## ADDENDUM #1 Lutz Office Tenant Improvement

### Lutz Office Tenant Improvement

**A13.1**  
10-16212.00  
5/13/2016  
Revisions

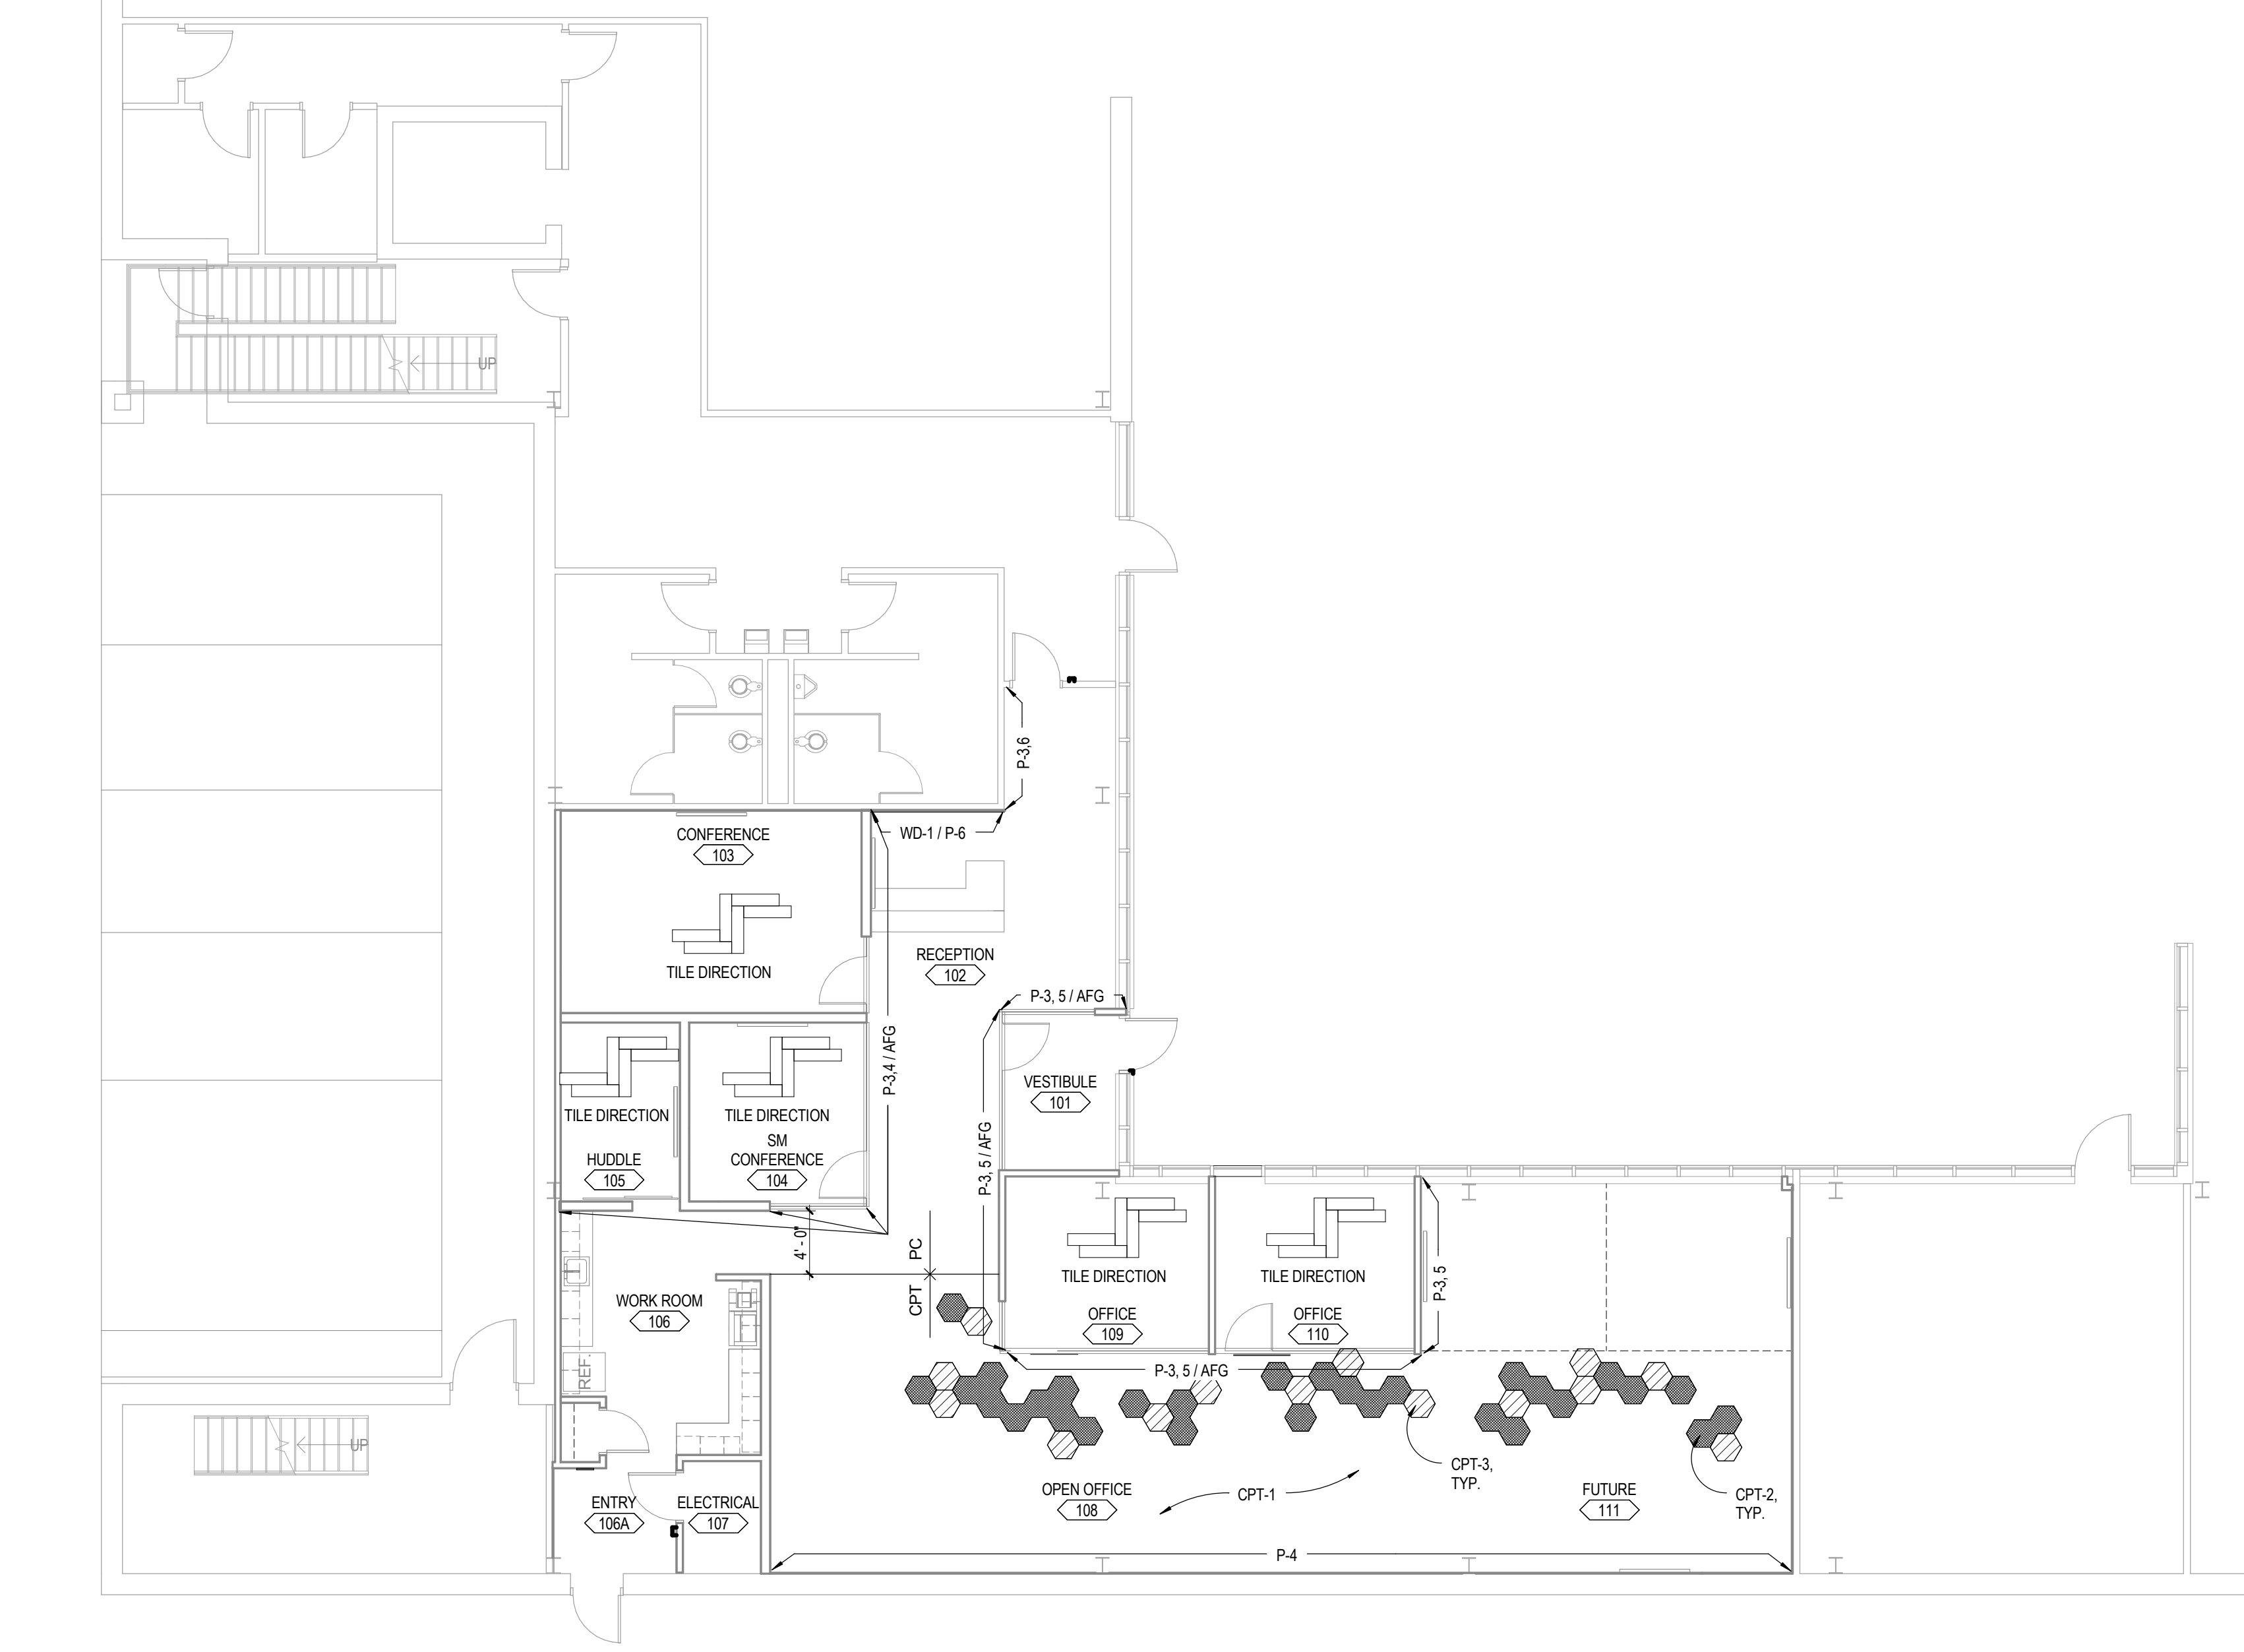
1. Bid Date Change
    - The bid date will be moved to Tuesday, May 31<sup>st</sup>, 2016 due to the prior bid date falling on Memorial Day.
  2. A13.1 was not previously included in the construction documents – see attached.
  3. See attached meeting minutes from the Pre Bid Meeting held today.
- End of Addendum -
